January 30, 2012

Spaceport Questions and Answers for the Southern Road Environmental Analysis RFP #12-495-00-00289

Southern Road Proposed Project Route

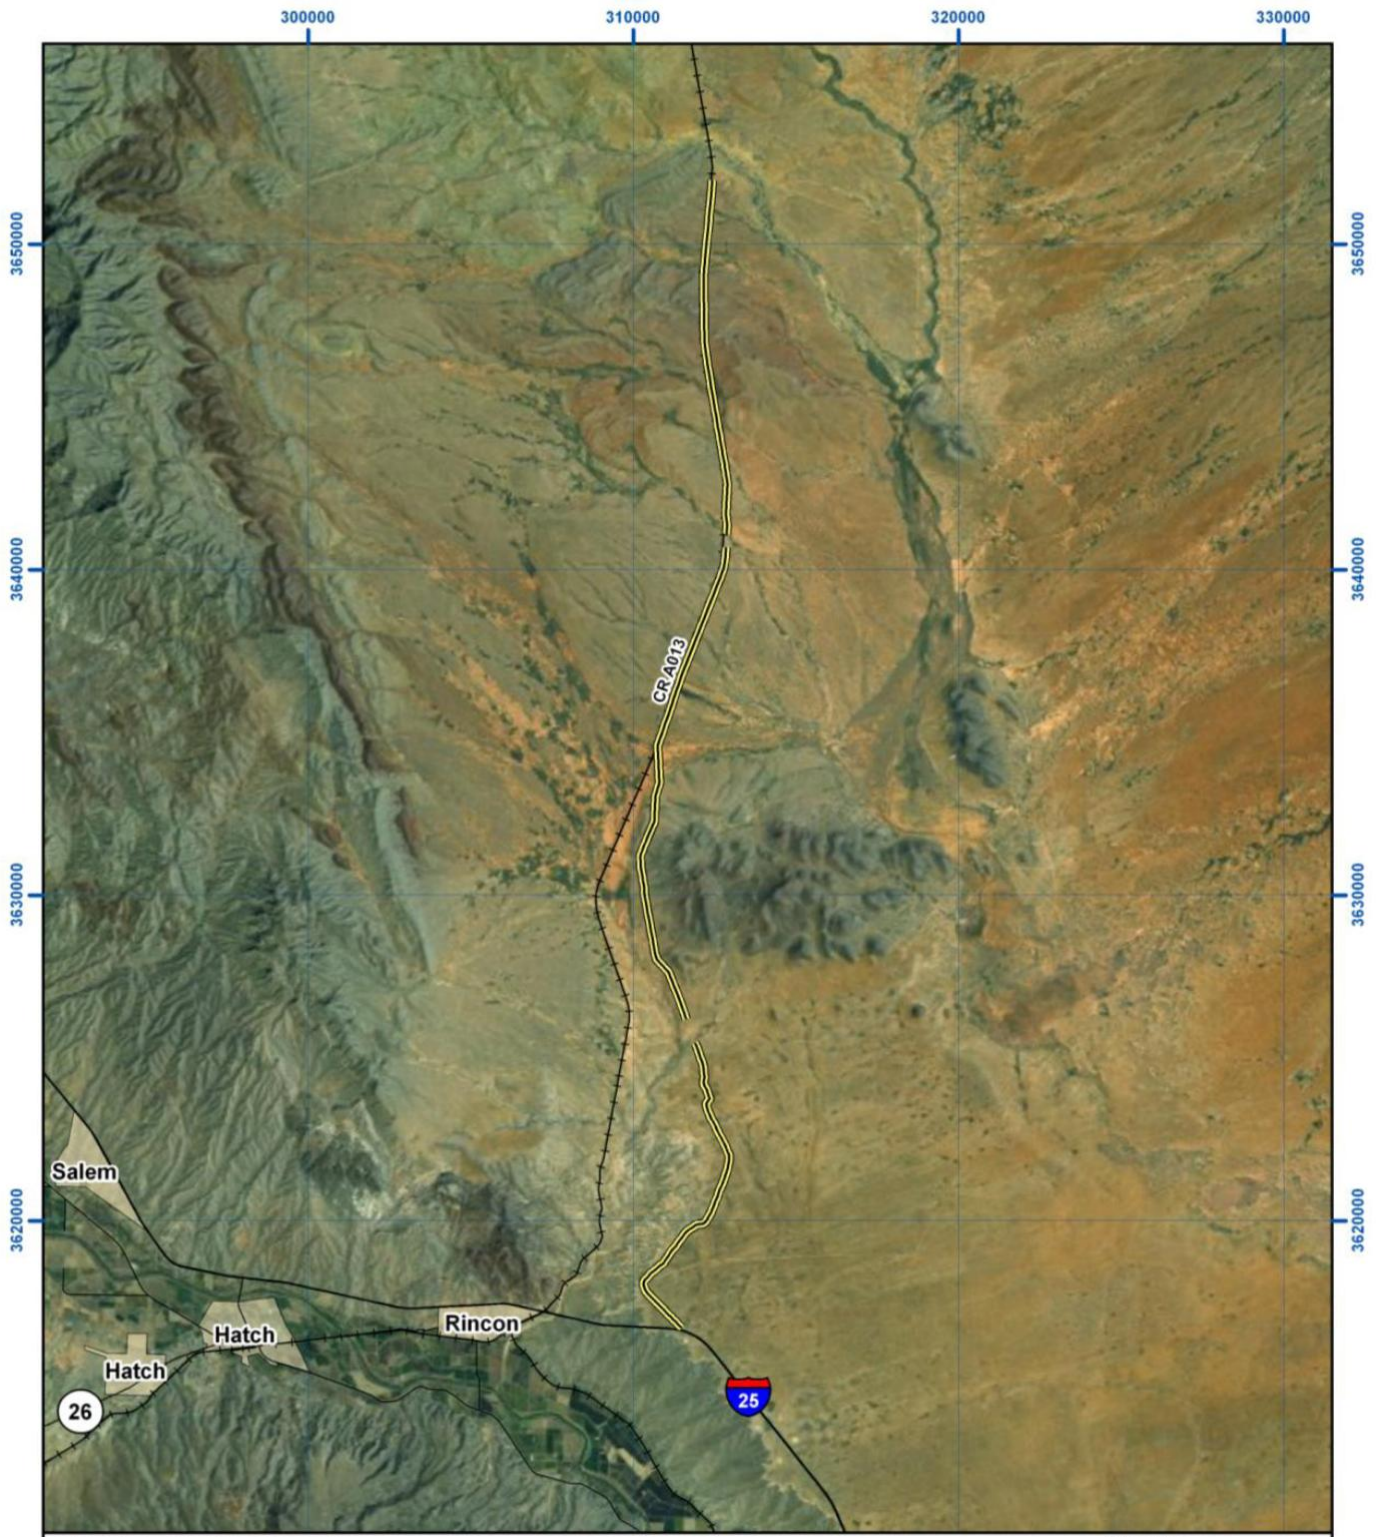
Q13. Can a map of the right-of-way be provided?

Q30. Are preliminary road plans available for review at Dona Ana County?

A: A map showing the proposed route is attached.

A: No. See attached map which shows the route.
